STAFF REPORT
KETCHUM PLANNING AND ZONING COMMISSION
REGULAR MEETING OF FEBRUARY 28, 2023

- PROJECT:** 691 N Spruce Avenue Residence
- APPLICATION TYPE:** Mountain Overlay Design Review (Application File No. P22-042B)
Lot Consolidation Preliminary Plat & Waiver (Application File No. P22-042A)

- PROPERTY OWNER:** Spruce and 6th LLC
- REPRESENTATIVE:** Jake Watkins, Roger Ferris + Partners (Architect)
- REQUEST:** Final Mountain Overlay Design Review and Lot Consolidation Preliminary Plat with Waiver Request for the development of a new 4,534-gross-square-foot one-family dwelling

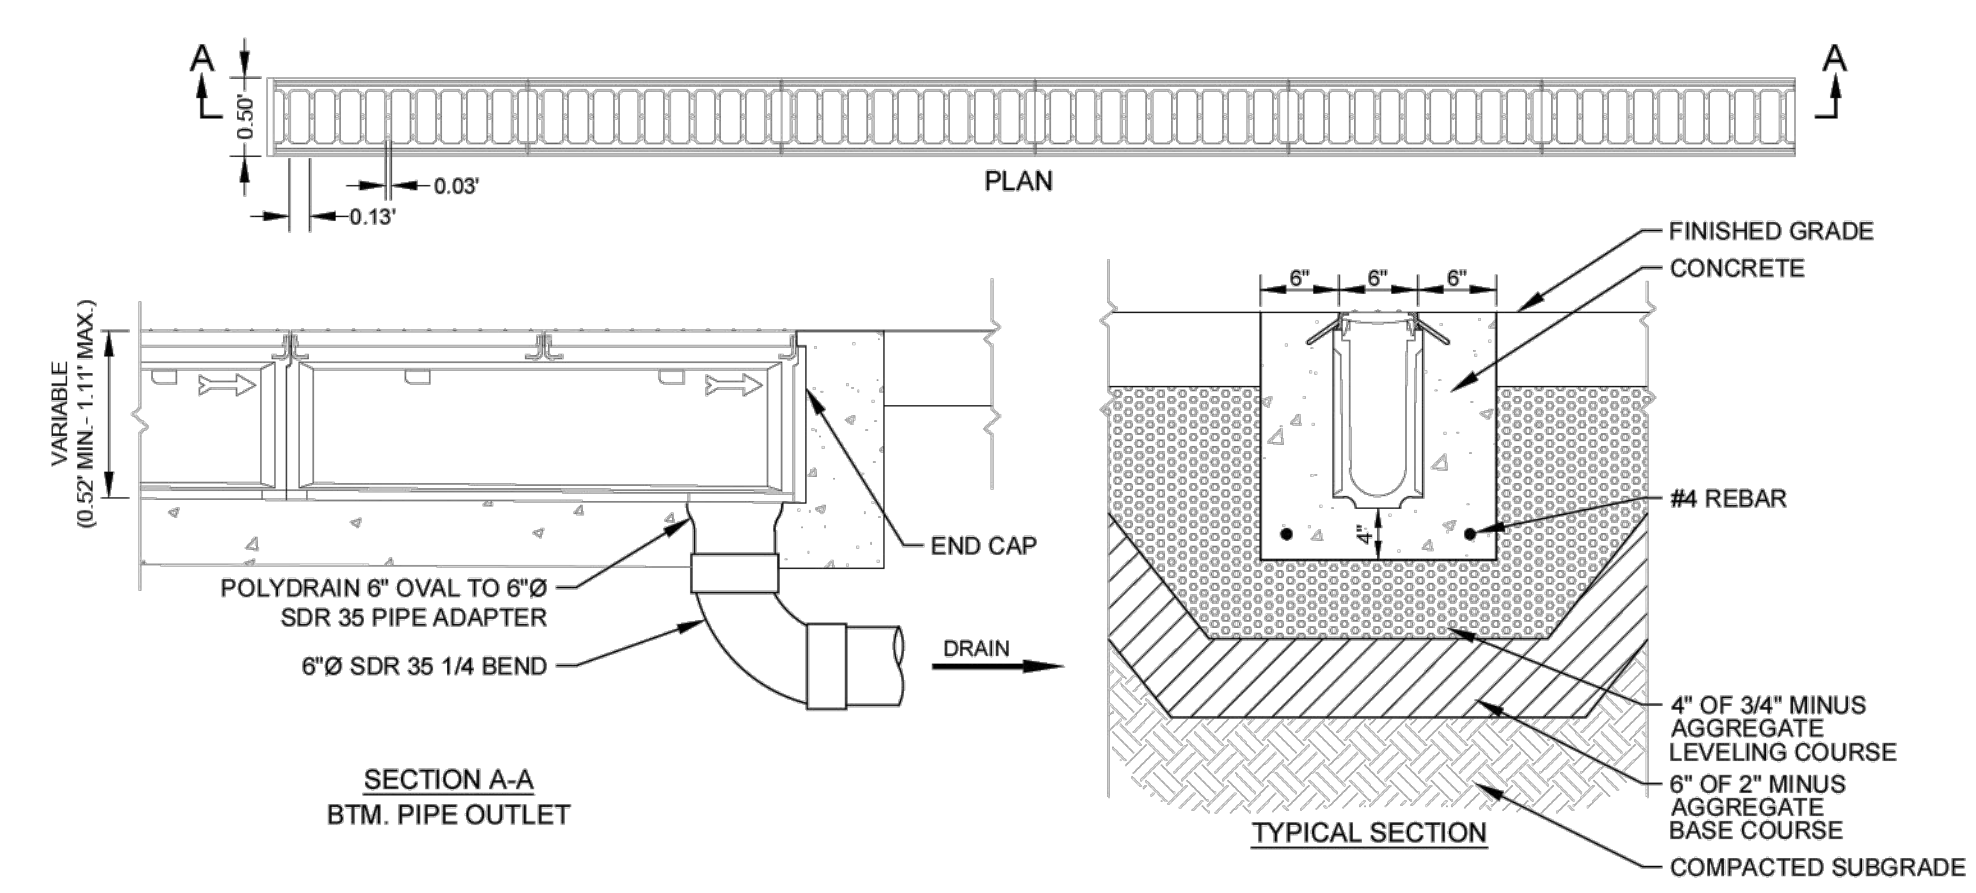
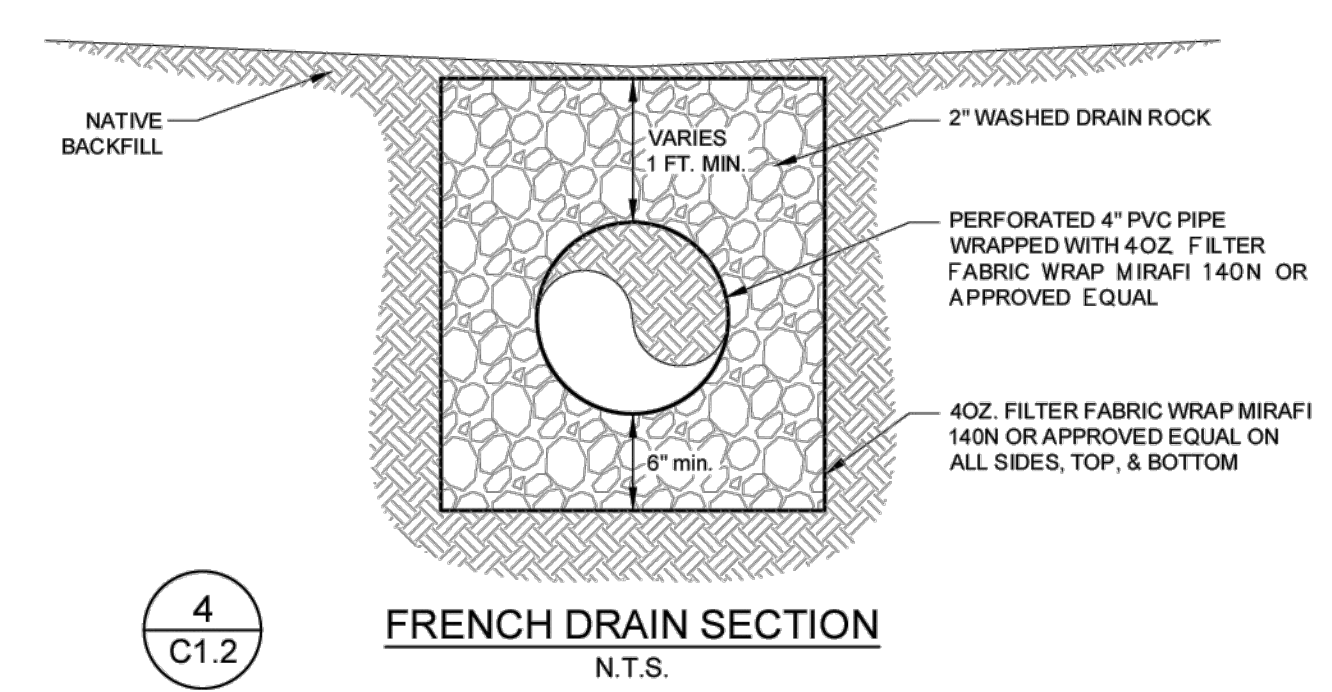
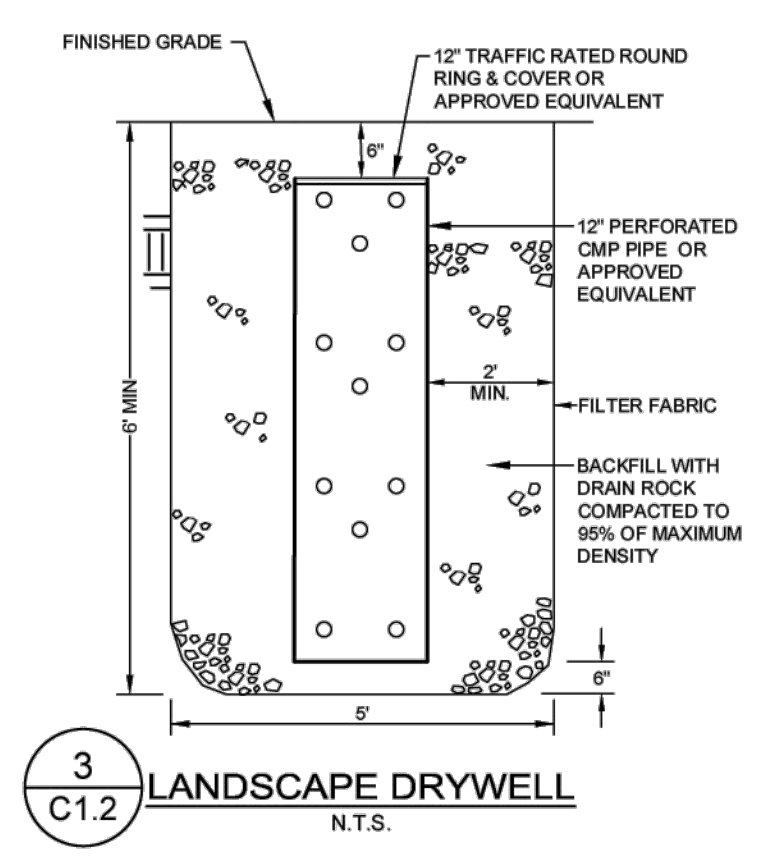
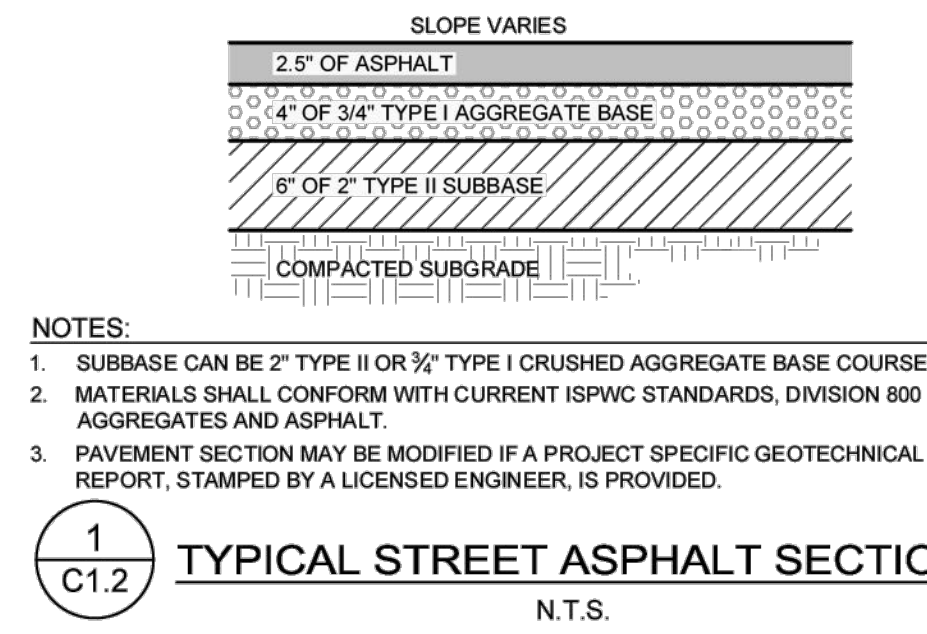
2. Comment: The site grading and drainage plan on Sheet C1.1 doesn't specify the proposed contour intervals for the driveway-grading improvements.

- Required Action: Please specify the proposed contour intervals for the driveway-grading improvements shown on Sheet C1.1 of the project plans.

3. Comment: The site grading and drainage plan on Sheet C1.1 shows that a new infiltration gallery (Note SO6) is proposed to be installed along the full length of the south side-yard setback area. The civil notes and details on Sheet C1.2 do not provide specifications for the proposed infiltration gallery.

5. Comment: The grading and drainage plan on Sheet C1.1 indicates that in addition to removing the existing nonconforming retaining walls on the subject property, the portion of the retaining wall that extends into the Spruce Avenue public right-of-way will also be removed. During our phone conversation on January 5th, 2023, you clarified that the entirety of the existing retaining wall that borders the dead end of Spruce Avenue is proposed to be removed.

- Required Action: Since the retaining wall bordering the dead end of Spruce Avenue is proposed to be removed, the proposed grading and drainage plan on Sheet C1.1 must be revised to specify how the finished grade proposed for the driveway access will tie into the existing grade of the hillside above the street.

- **Required Action:** Please add the proposed amount of cut and fill in cubic yards to the site grading and drainage plan on Sheet C1.1.

The proposed contours are shown on the driveway. We clarified this with Abby Rivin (P&Z staff) and Robyn Mattison (City Engineer) on a conference call held on Friday, Jan. 13th. See sheet C1.1 by Galena Engineering.

Details have been added. We reviewed this with Abby Rivin (P&Z staff) and Robyn Mattison (City Engineer) on a conference call held on Friday, Jan. 13th. See sheets C1.1 & C1.2 by Galena Engineering.

The snowmelt system location and area have been indicated on the plans. See sheet C1.1 by Galena Engineering.

The cut and fill figures have been added to the plans. See sheet C1.1 by Galena Engineering.

LANDSCAPE PLAN
RESIDENCE
691 N. SPRUCE AVE, KETCHUM, IDAHO

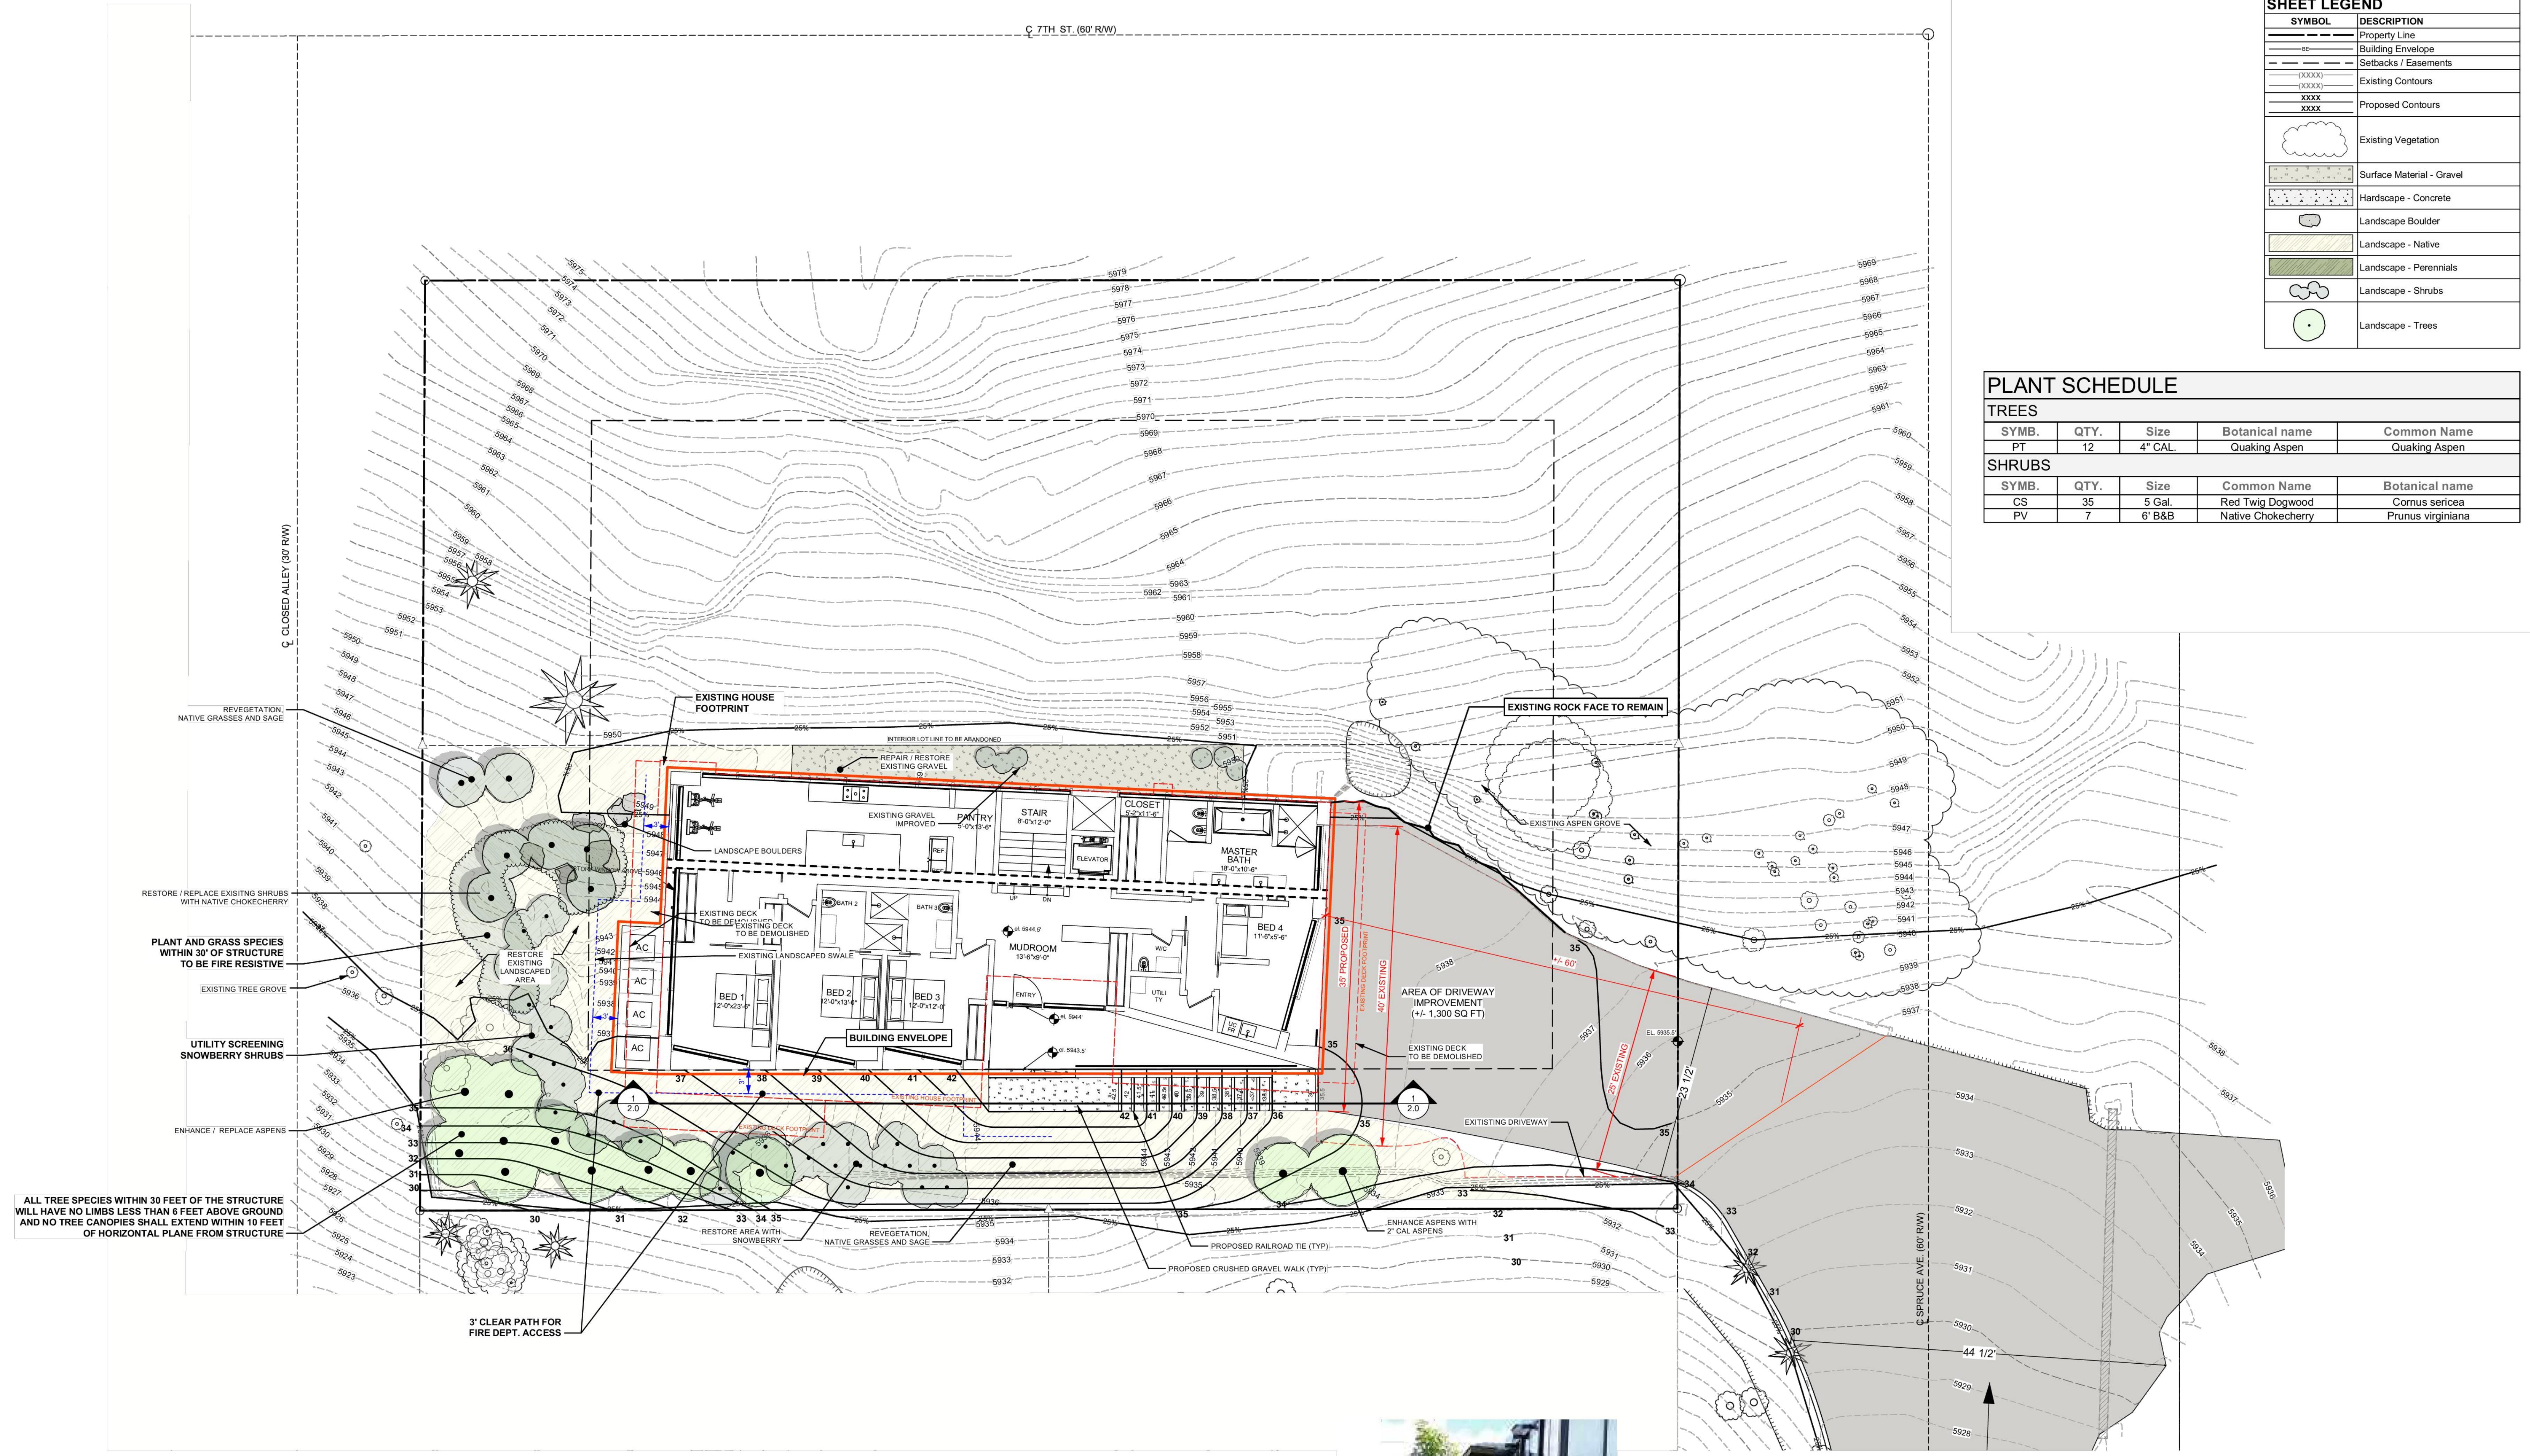
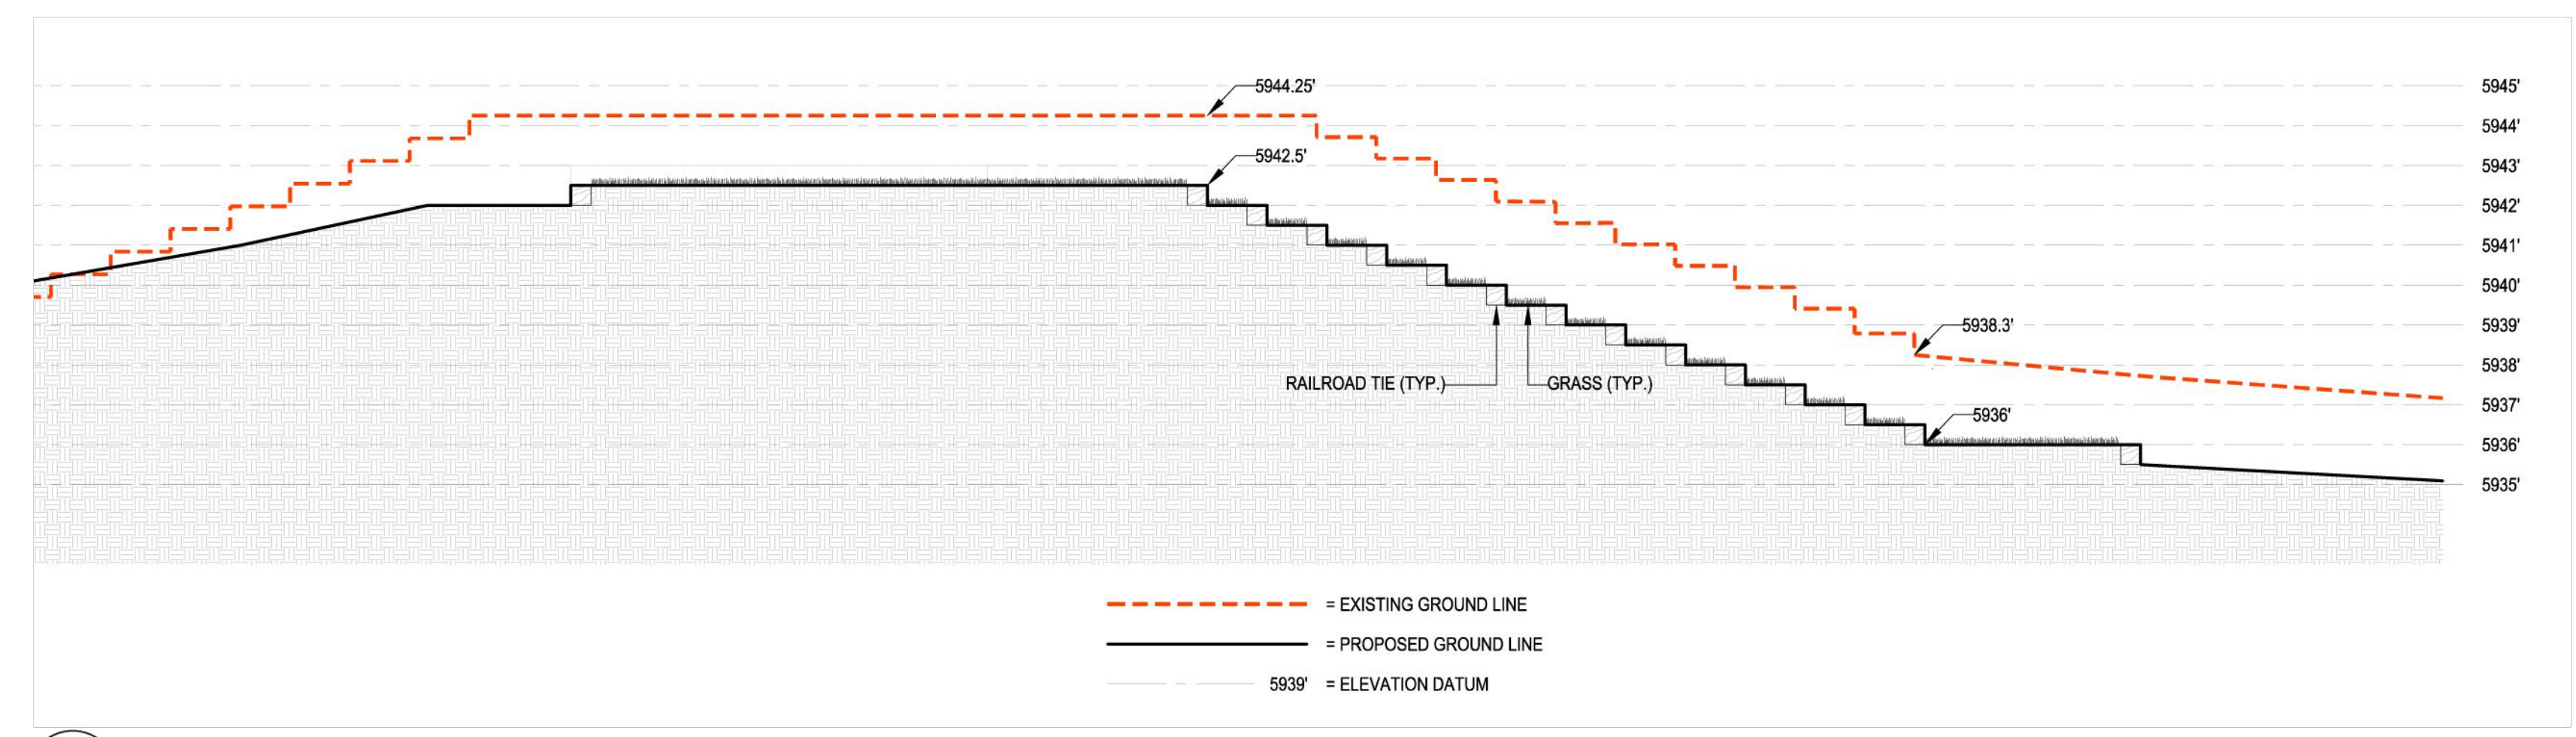
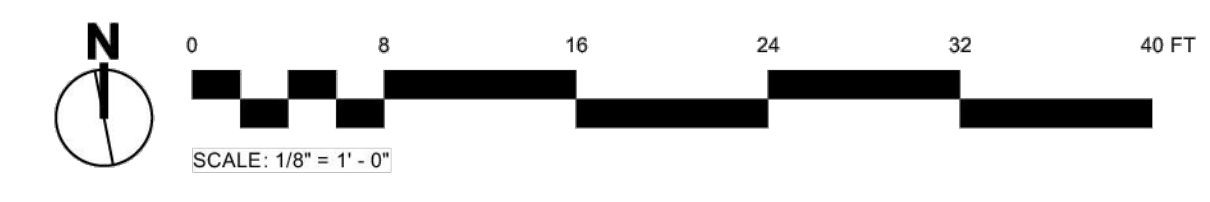
4. Comment: The landscape plan on Sheet L2.0 specifies that the driveway will include a snowmelt system. In addition, Sheet L2.0 shows that two snow storage areas will be provided on site and includes a note stating that snow will be hauled off site if needed. The engineered plans on Sheets C1.1 and C1.2 show that a new asphalt driveway will be constructed. The civil drawings do not specify that the driveway will include a snowmelt system. Per our phone conversation on January 5th, 2023, the driveway will include a snowmelt system. Pursuant to Ketchum Municipal Code §17.96.060.H4, snowmelt is permitted in lieu of providing snow storage areas on site. The on-site snow storage areas and snow hauling are not required as the driveway is proposed to include a snowmelt system.

- Required Action: Please resolve the discrepancy between the civil and landscape drawings and revise the civil plans to specify the location and dimensions of the heated driveway area and snowmelt system. As on-site snow storage areas and snow hauling are not required per Ketchum Municipal Code §17.96.060.H4, Staff recommends that you remove these from the snow storage plan indicated on Sheet L2.0.

8. **Comment:** The landscape plan on Sheet L2.0 includes a picture illustrating the design concept proposed for the entry stairs. The picture shows stone treads separated by grass. The entry stairs proposed for the project are comprised of railroad ties that form risers along a gravel pathway.

- **Staff Recommendation:** Staff recommends that you add a note to Sheet L2.0 clarifying that the picture is an illustrative example of the design concept to minimize confusion for the public and Planning and Zoning Commission.

The snow storage areas and snowmelt system indicated on the landscape plan have been removed. See sheet L2.0 by BYLA.

A note has been added indicating that the image is for design intent only. See sheet L2.0 by BYLA.
